ARMY ENGINEER DISTRICT NORFOLK VA
NATIONAL DAM SAFETY PROGRAM, SPRING VALLEY LAKE DAM (INVENTORY --ETC(U)
NOV 80 J A WALSH

Name Of Dam: SPRING VALLEY LAKE
Location: CITY OF ROANOKE, VIRGINIA
Inventory Number: VA 77002

PHASE I INSPECTION REPORT NATIONAL DAM SAFETY PROGRAM

NOVEMBER 1980

PLATE II

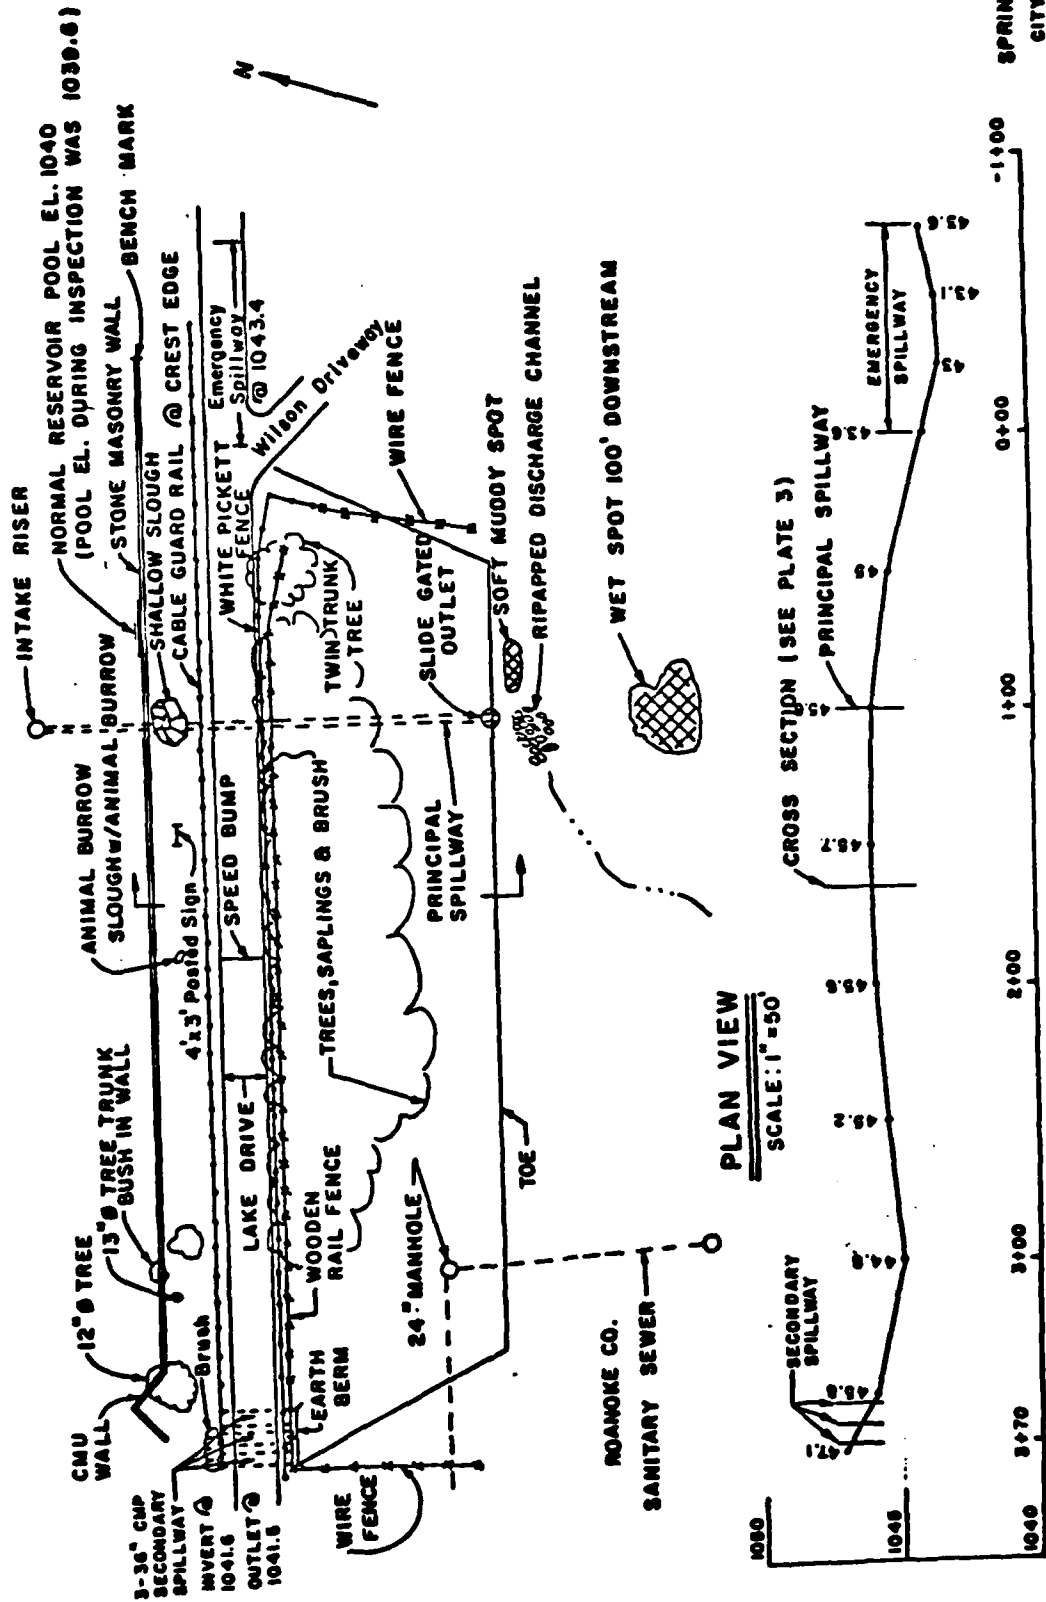
The upstream slope is covered with trimmed grass. Also, there are three trees and some brush on the slope as located on Plate II, Appendix I. The downstream slope is sparsely vegetated with grass. Portions of the slope are vegetated with bushes, saplings, and trees as shown in Photo. No. 3, Appendix II. The immediate downstream area is a fenced horse pasture area and the animals graze on the downstream slope.

a. The slough on the upstream slope and the wet spot just left of the principal spillway outlet should be monitored. If the slough enlarges, and/or erosion develops along the outlet pipe, the reservoir should be immediately drawn down and a professional geotechnical engineering firm should be contacted for further evaluation.

c. The shrubs that block the entrance to the three 36-inch CMP should be cut to the ground. The berm that blocks the discharge invert of the three CMP should be cut down to below the invert.

b. All shrubs and trees up to 3 inches in diameter should be cut to the ground. Trees greater than 3 inches should have their root systems removed. Subsequent holes should be backfilled with compacted material and seeded.

e. The animal burrows on the upstream slope should be backfilled and seeded.

PHOTO *2 UPSTREAM FACE OF DAM

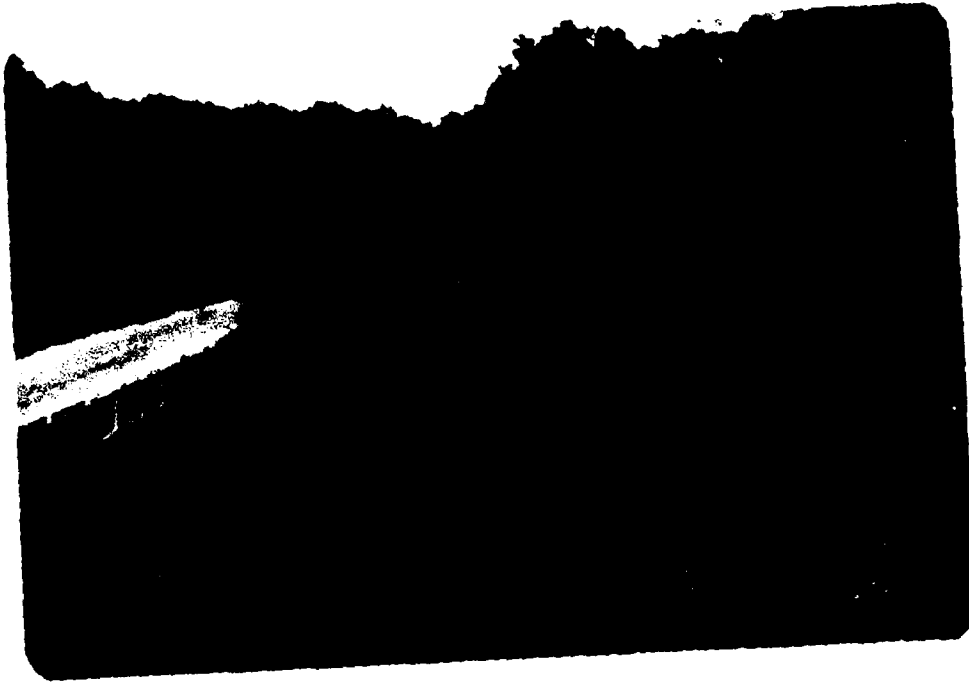
There is a shallow slough on the upstream slope in line with the principal spillway. The slough is old and vegetated. It is 17 feet wide. It extends from the top of the retaining wall to one foot below the crest. The wall shows no signs of movement. There are no other signs of erosion other than a second animal borrow on the upstream slope just below the speed bump. The upstream slope is shown in Photo. No. 2, Appendix II.
